EPA-SAB-EEC-03-001

OFFICE OF THE ADMINISTRATOR  
SCIENCE ADVISORY BOARD

Re: Review of the Office of Solid Waste's Study, *Industrial Surface Impoundments in the United States*: An EPA Science Advisory Board Report

**Figure 2. Exposure pathways for active surface impoundments considered for human and ecological receptors.**

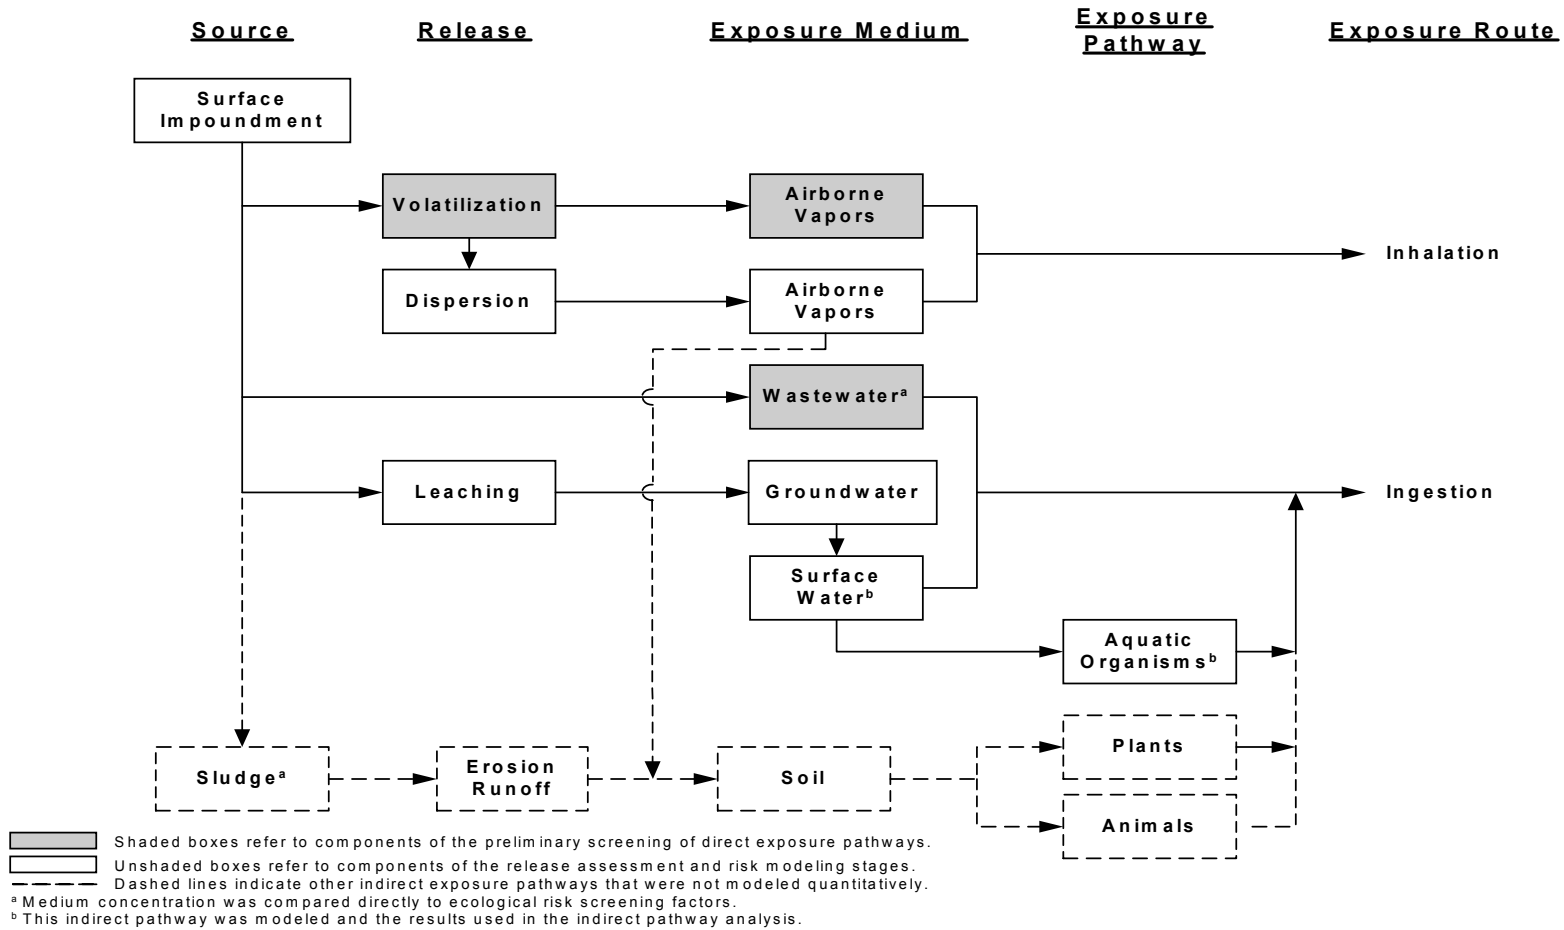
Subcommittee notes that contaminant source term concentrations need to be determined either through the use of monitoring data or predictions of contaminant release rates/events using containment system failure/liner permeation models, for input into the risk models. As indicated by EPA in Figure 2 (designated as Figure 3.1 on page 3.3 of OSW's report<sup>3</sup>), the release scenarios

that are considered to impact upon source terms are volatilization / dispersion, leaching and erosion/run off. Analyses are likely to show that for some impoundments located in the regions mentioned in the preceding paragraph, this suite of release scenarios is incomplete. Furthermore, EPACMTP does not model the impacts of transient events and this should be stated under "model simplifications" on page 3-18 of the report (USEPA, 2001).

<sup>3</sup> One of the SAB Executive Committee Members suggested to make the following changes on the figure:

1. Change the title to "Conceptual model of the potential relationships between chemical stressors from active surface impoundments and human and ecological receptors."
2. Switch "Plants" and "Animals" boxes, add a dotted arrow that connects between the arrow (between "Airborne Vapors" and ""Soil") and "Animals" pointing toward "Animals," do the same for "Plants," add a dotted arrow between "Aquatic Organism" and "Animals" pointing toward "Animals," and add a dotted arrow between "Animals" and "Plants" pointing toward "Animals."
